Service Engineering Operations
Customer Service Division

SUBJECT: **Safety Recall 24S71**
Certain 2024 Model Year Ranger
Fuel Vapor Line Bundle Bracket Inspection

Safety Recall 24S71

FIGURE 1

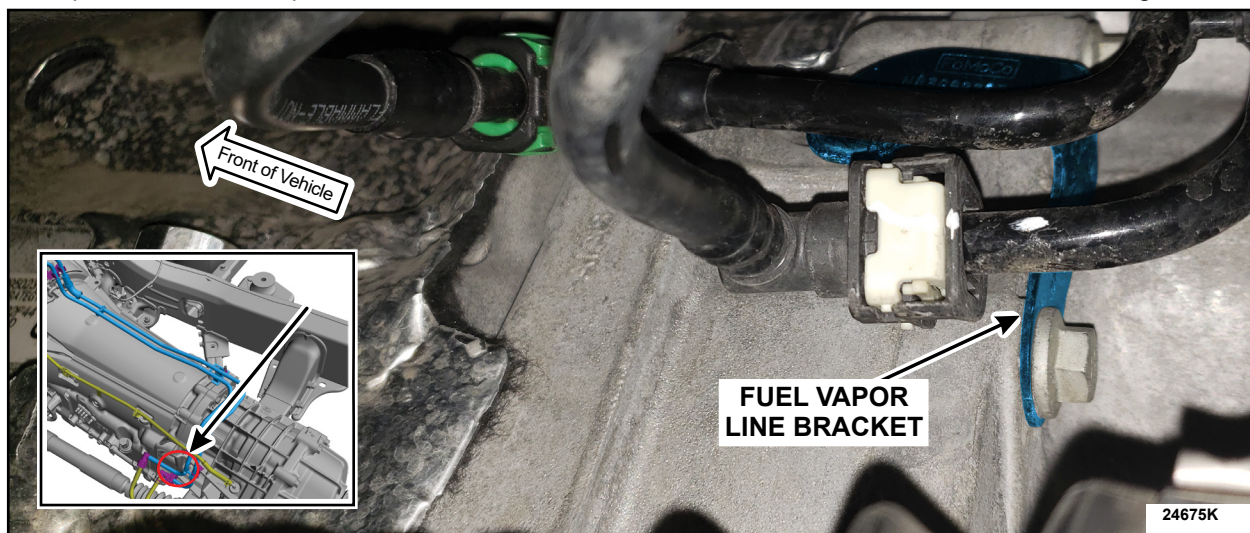
1. Inspect for the fuel vapor line bracket at the rear of the transmission on the driver side. See Figure 1.

2. Is the fuel vapor line bracket indicated in Figure 1 present?

- No - This FSA does not apply.
- Yes - Proceed to Step 3.

FIGURE 3

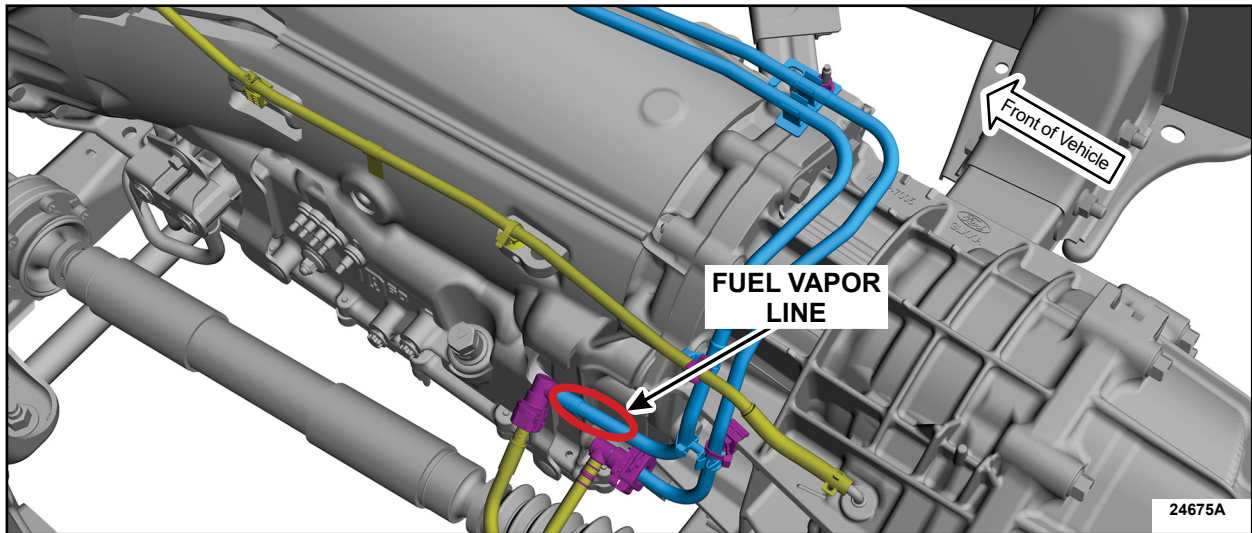
4. At the rear of the transmission on the driver side, locate the fuel vapor line indicated in Figure 3.

FIGURE 4

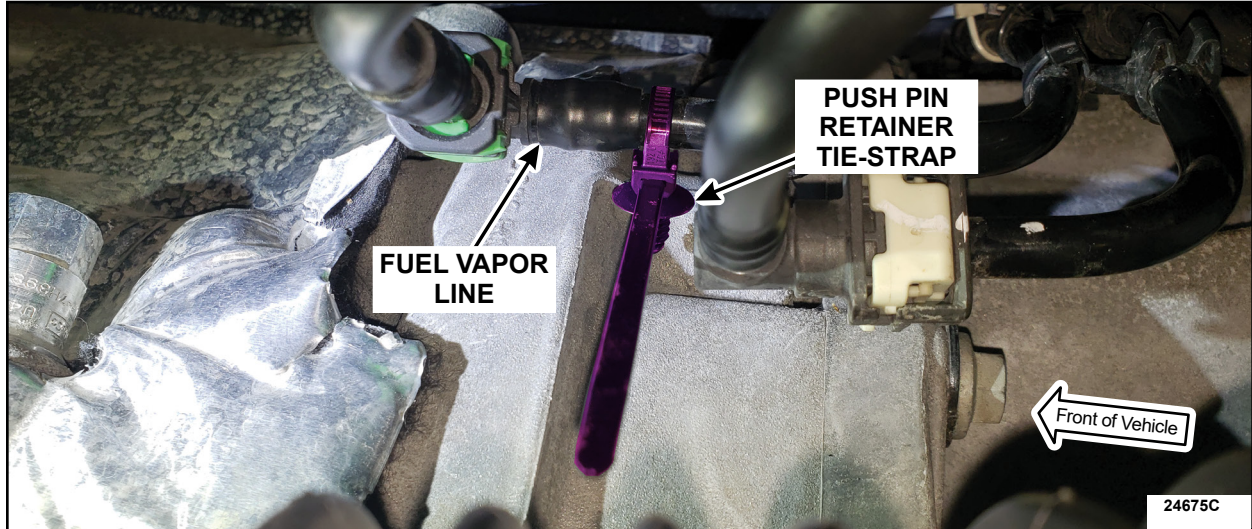
5. Loosely install the push pin retainer tie-strap to the fuel vapor line indicated in the previous set. See Figure 4.

NOTE: Do not tighten the push pin retainer tie-strap at this time.

FIGURE 5

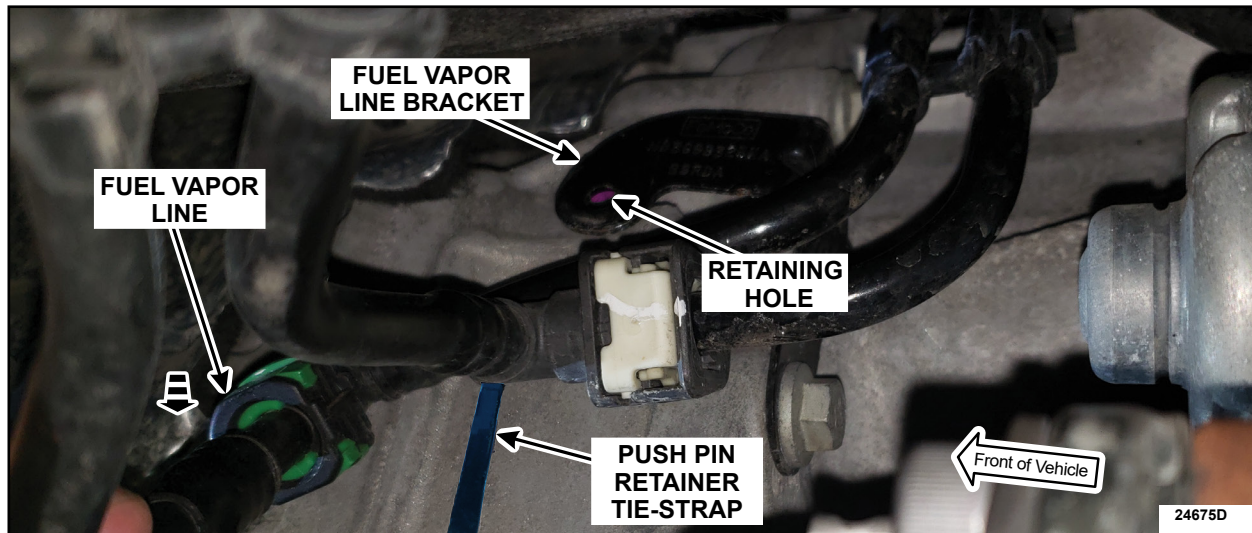
6. Slightly pull the fuel vapor line down to locate the retaining hole in the fuel vapor line bracket. See Figure 5.

FIGURE 6

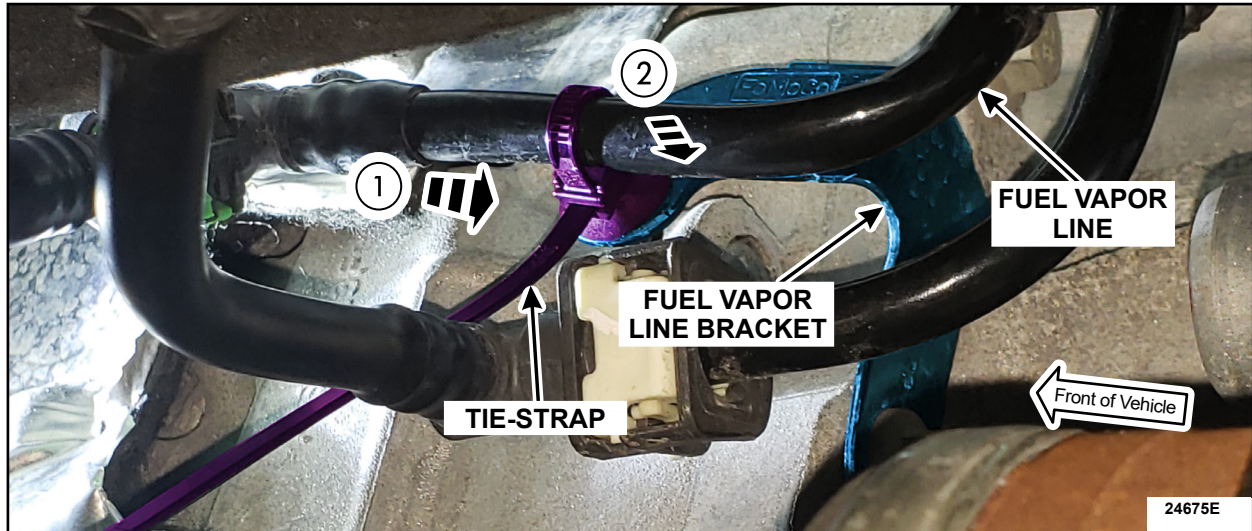
7. Attach the push pin retainer to the fuel vapor line bracket. See Figure 6.

- a. Slide the tie-strap towards the rear of the vehicle on the fuel vapor line.
- b. Install the push pin retainer into the retaining hole on the fuel vapor line bracket.

FIGURE 7

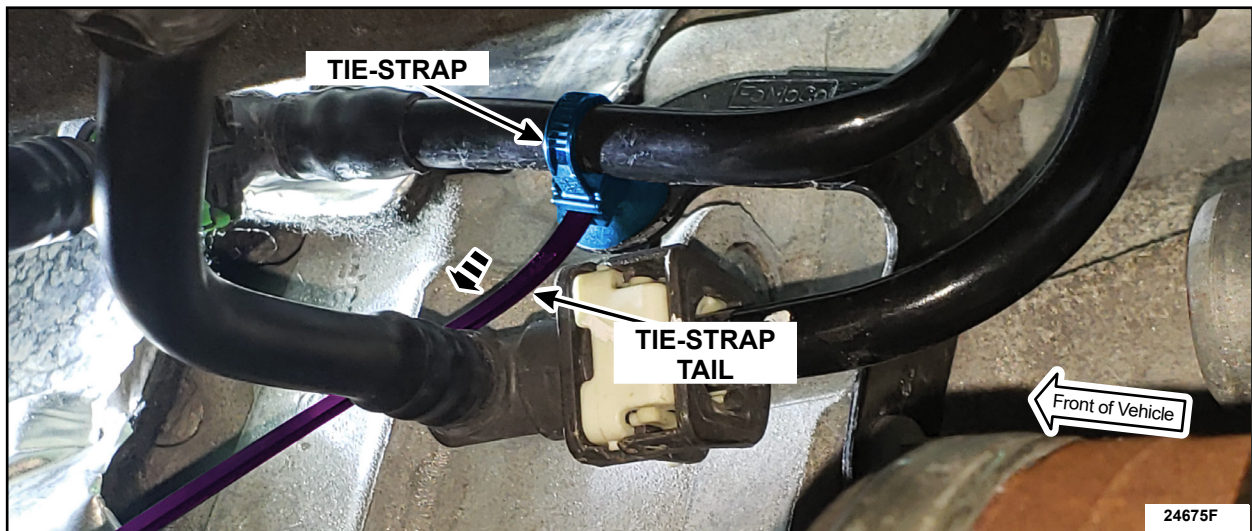
8. Tighten the tie-strap by pulling the tie-strap tail. See Figure 7.

NOTE: Needle nose pliers may assist in tightening the tie-strap.

NOTICE: Do not over tighten the tie-strap. Damage to the fuel vapor line may result.

FIGURE 8

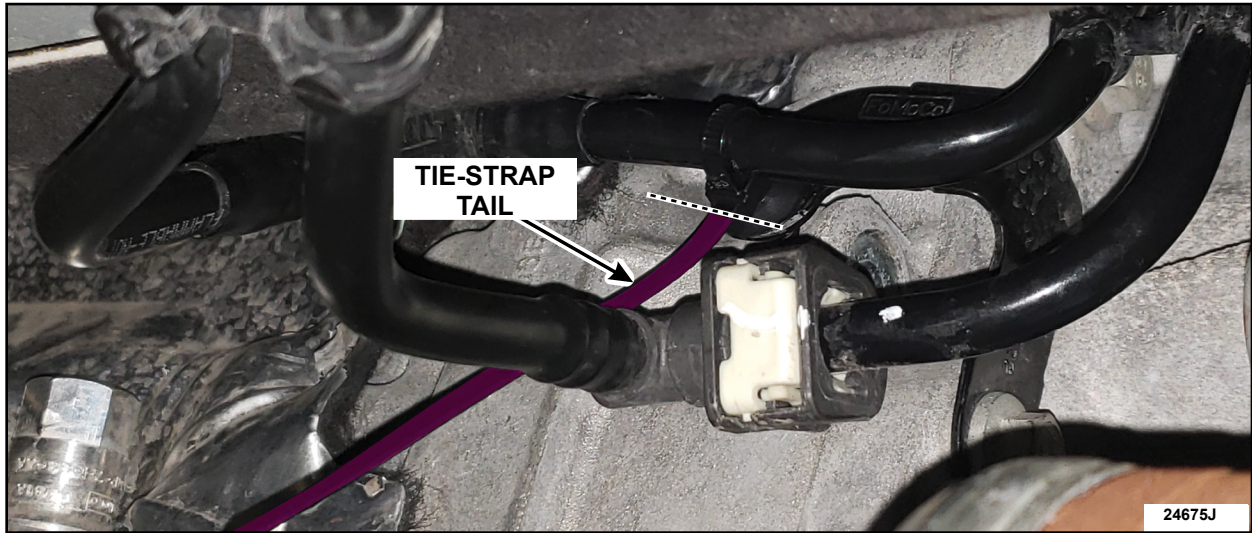
9. Cut the tie-strap tail as close to the tie-strap locking mechanism as possible. See Figure 8.
